PLANNING COMMISSION STAFF UPDATE MEMO

Planned Development District – 6695 S. Wasatch Blvd.

July 1, 2020

PDD-19-001

Figure 2- Current Proposed Site Layout – See Attachment X For High-Resolution

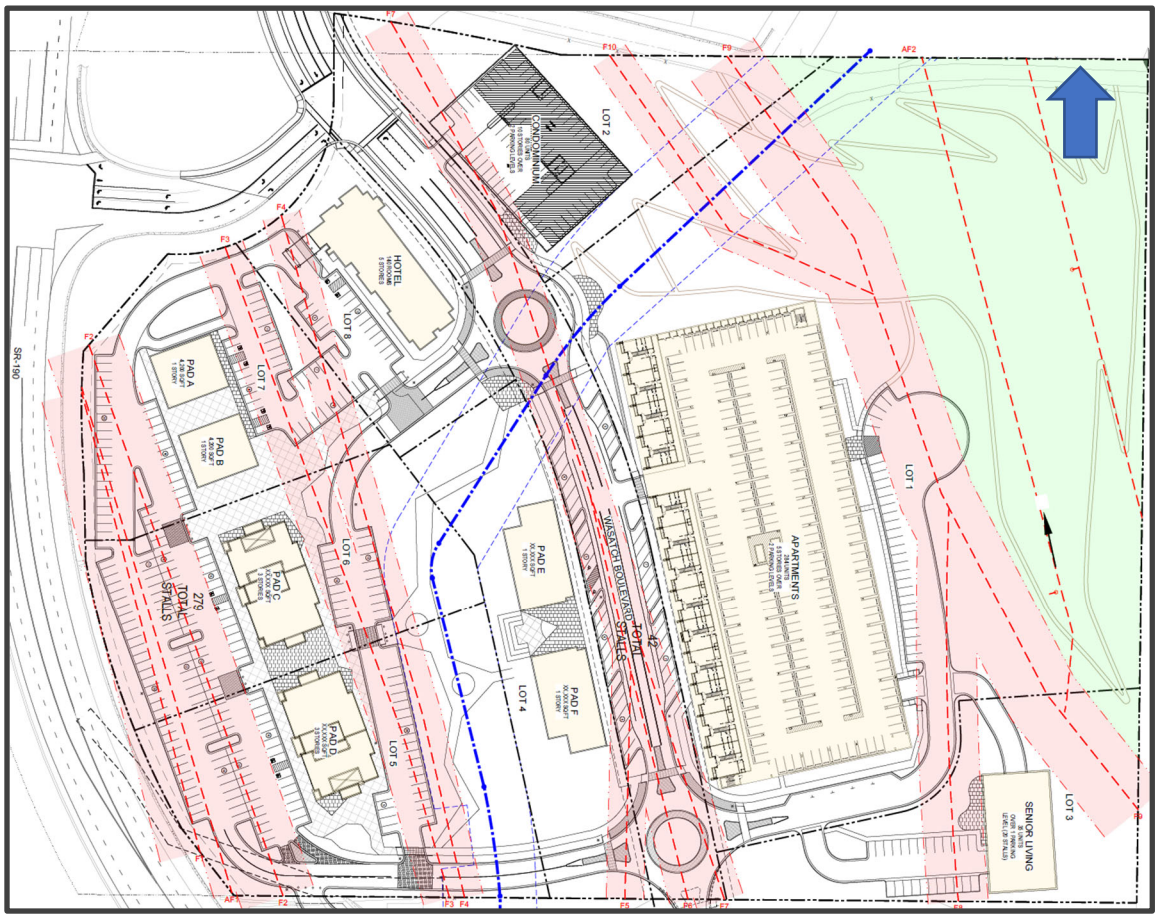
Note: *This report contains several graphics of the proposed development plan. Figure 2 is the current layout. Other site layouts are included which contain outdated building, driveway, and site layouts. These older plans are included to illustrate landscaping, open space, plaza, and site amenities, cycling and pedestrian circulation, and site constraints. All these plans are required to be updated with the current site layout prior to Planning Commission approval of the development plan.*

Table 1 – Development Plan Summary. *Based on the number of proposed market rate apartment and condominium units, at least 42 affordable housing units are required.

FIGURE 5 - LANDSCAPING/PUBLIC SPACE DETAILS (HOTEL AND PAD A ARE OUTDATED).

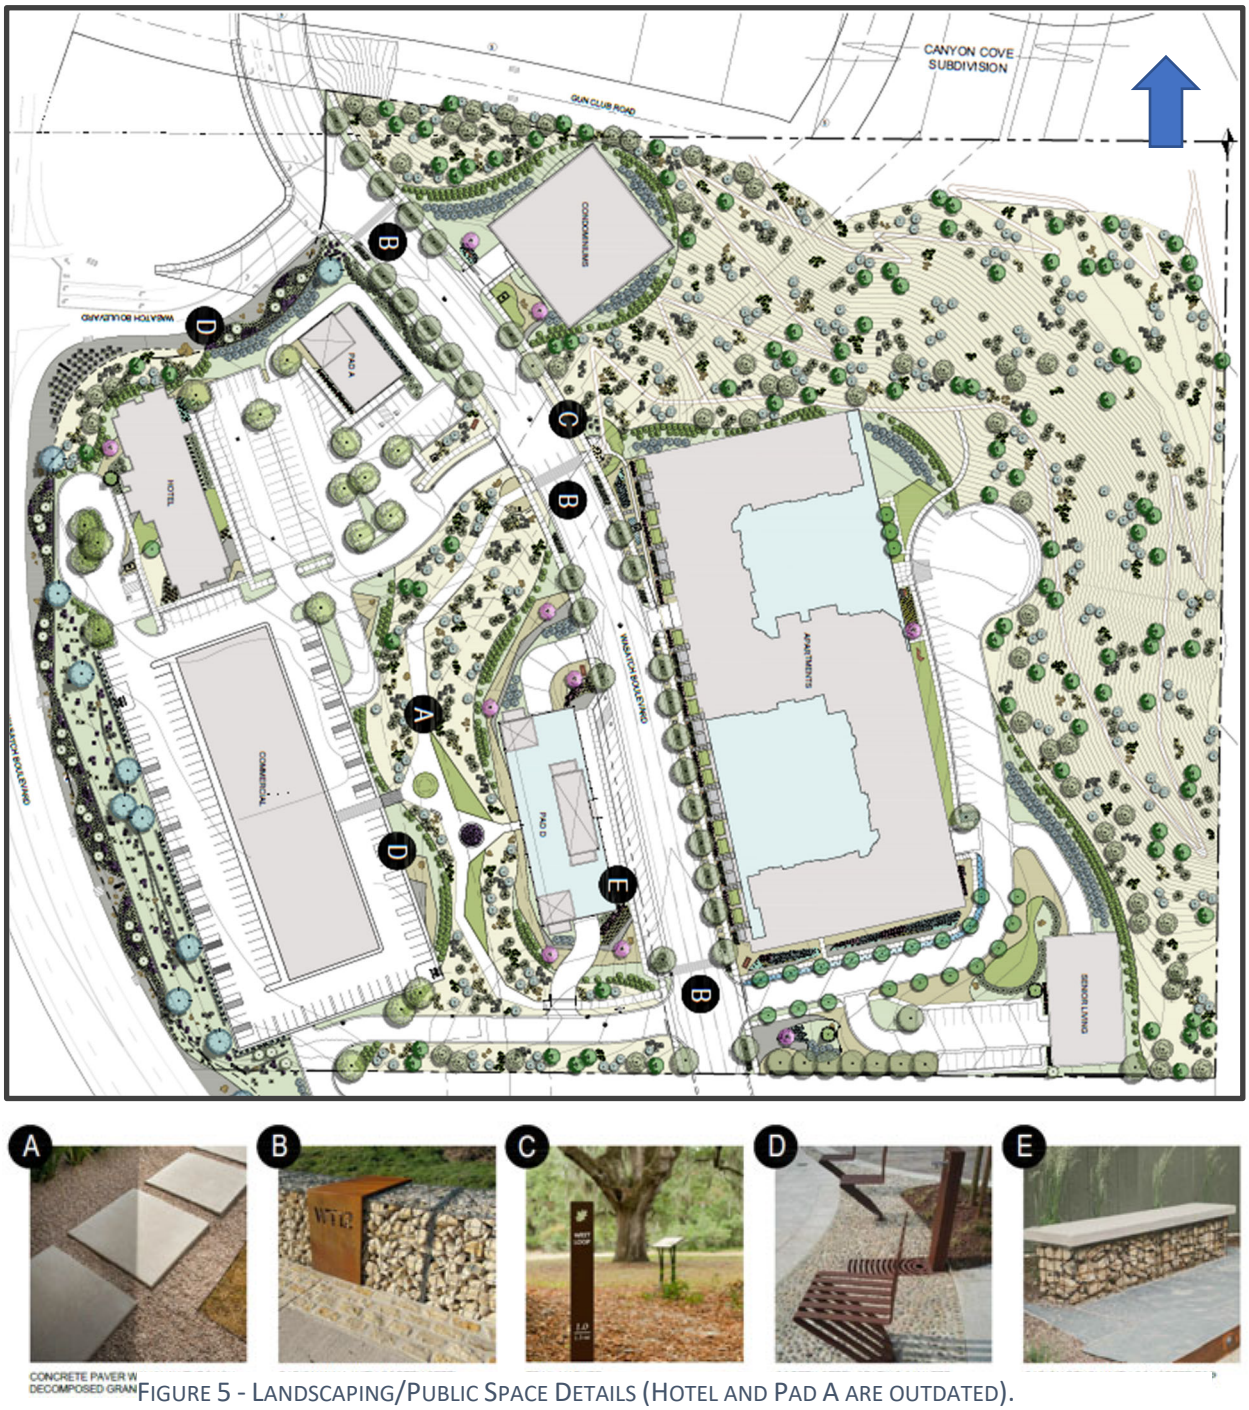
The applicant has amended the site plan twice of their own accord and have made additional changes based upon staff and Architectural Review Commission feedback. Accordingly, there is inconsistency between the current development plan and supporting documents such as the master landscape plan. All site plans need to be consistent with each other as they will be adopted as part of the regulating zoning ordinance.

See Figure 5 for details on the vegetation proposed for the hillside. Mature vegetation assist hillside stability, although establishment must be carefully done as to water avoid run-off and soil oversaturation.

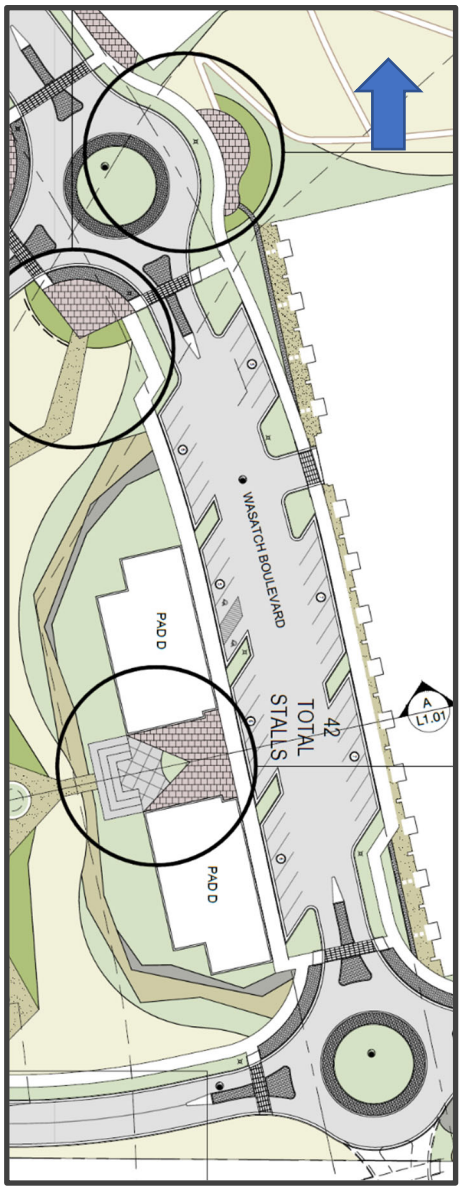
Unified Fire has reviewed the plan and has found access to each building site acceptable. Proposed roundabouts will need to be designed with an appropriate radius to allow for sufficient fire apparatus turning.

FIGURE 7 - FUTURE ACCESS POINTS FOR GRAVEL PIT REDEVELOPMENT AREAS

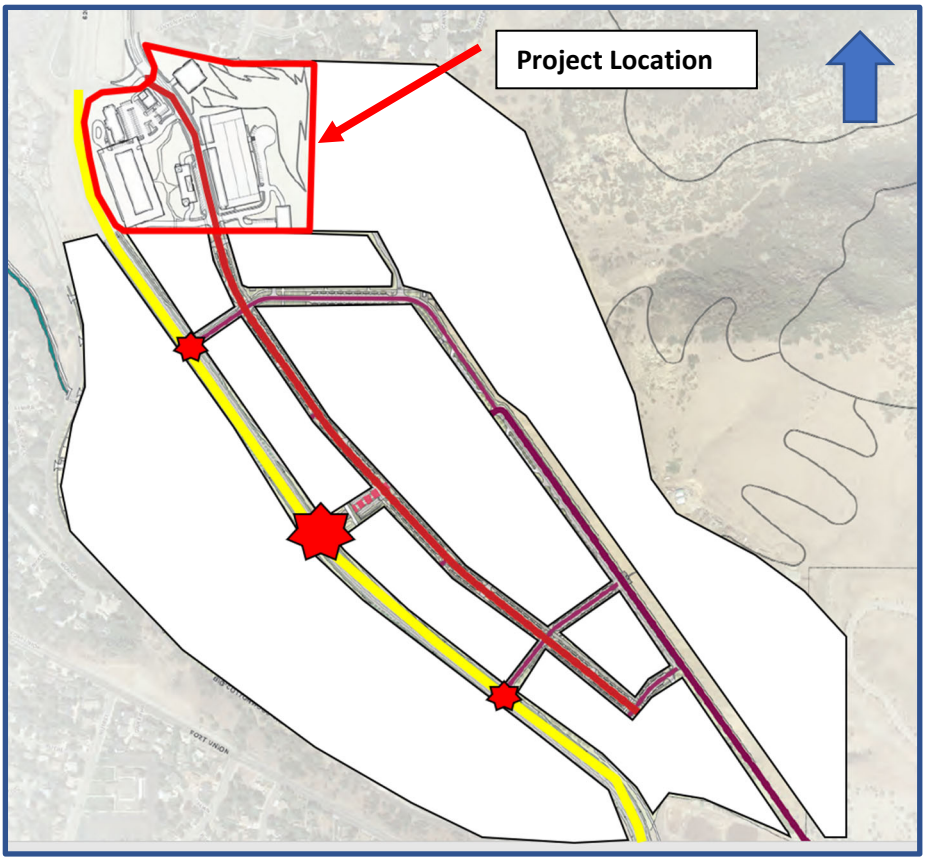
SR-190 is a Utah Department of Transportation (UDOT) highway. The City does not control the ability to add signals or street access onto this route. Staff understanding, based on UDOT State Administrative Rule 930-6-7, that access from this site onto SR-190 would not be permitted, primarily for three reasons:

1. Exceptions for access are not granted when there is a reasonable alternate access. Access onto Wasatch Blvd is a reasonable alternative to SR-190 in this situation.
2. Minimum street spacing from an intersection is 1000 feet and the spacing from Wasatch Blvd centerline to the edge of the property is approximately 800 feet. Signalized intersections require ½ mile of spacing.[1]
3. The property south of this site has three streets (one signalized) planned. When developed, the street labeled as "Upper Wasatch" on the development plan will have access to exit the site through these egress points.

Documentation from UDOT confirming the application of this rule and any prohibition on street access onto SR-190 for this site will be requested of the applicant to obtain.

FIGURE 8 – EXISTING AND PROPOSED SITE GRADING BASED ON OLD SITE PLAN LAYOUT.

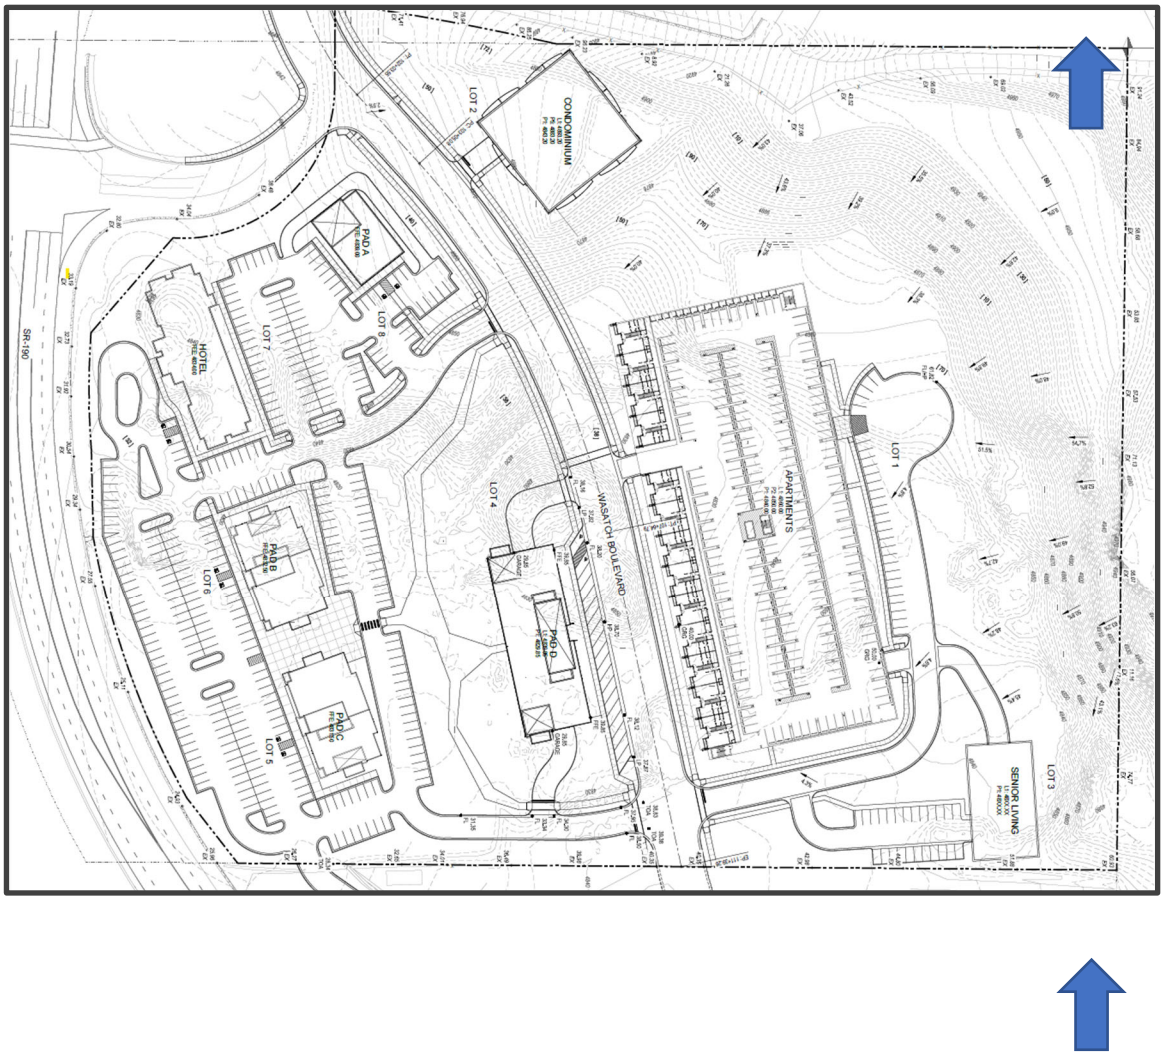
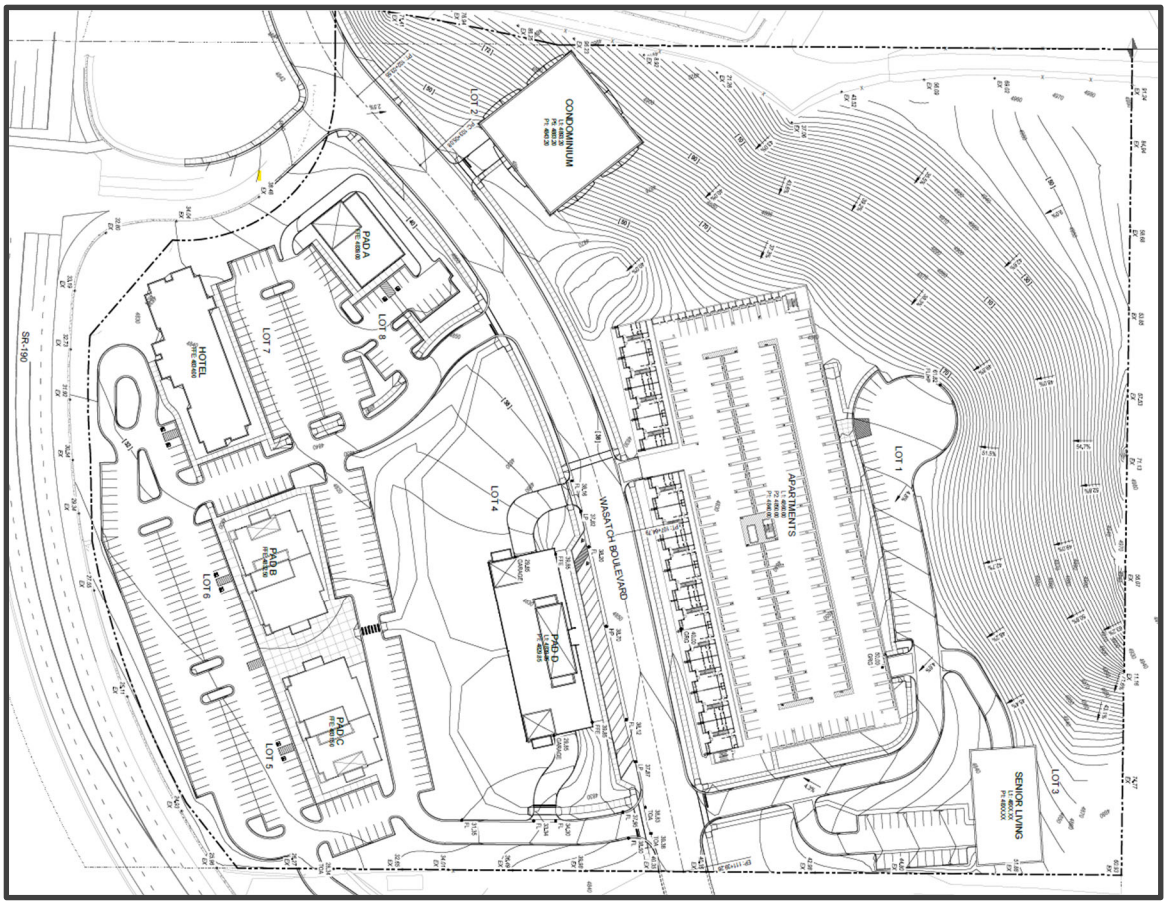
The applicant has provided additional details on the initial preliminary grading plan on the strategy to reclaim the slope as shown in Figure 9.

Additional Reclamation Information Needed

Public works is requesting additional planning on the reclamation prior to providing a recommendation on the development plan. The reclamation plan shall include at a minimum:

- Scope of the disturbed areas
- Drainage impact to native vegetation
- Slope stabilization methods and compaction requirements
- Erosion control methods and Revegetation Plan

Figure 9- Major Site Constraints – Red: Fault Setback Area. Orange: MDWSS Salt Lake Aqueduc

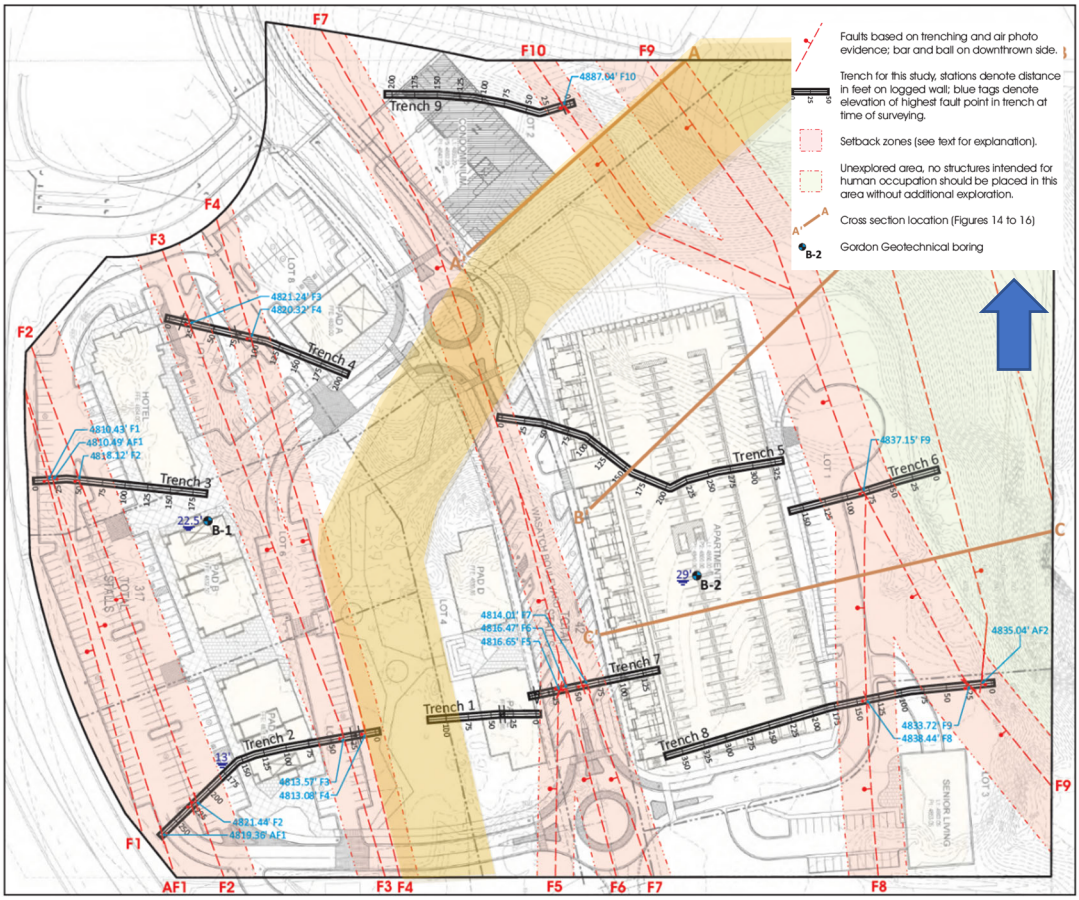
Red areas on the above diagram indicate fault lines and their required setbacks. Per the Surface Fault Rupture Study, no structures intended for human occupancy should be located in these areas. Streets, driveways, yards, parking, and other non-occupied non-attached structures may be constructed in these areas.

The **orange** area is an easement for the Metropolitan Water District of Salt Lake and Sandy (MWDSS) and created to house Salt Lake Aqueduct. No building and only limited surface development, as approved by MWDSS.

As final plan design-level geotechnical engineering studies required for each final phase may present, and as Significant cuts could change fault locations and setback zone calculations, staff recommends the inclusion of ordinance language that indicates that additionally recommendations from qualified geologic engineers and accepted by the Public Works department may negate approved locations on the Development Plan.
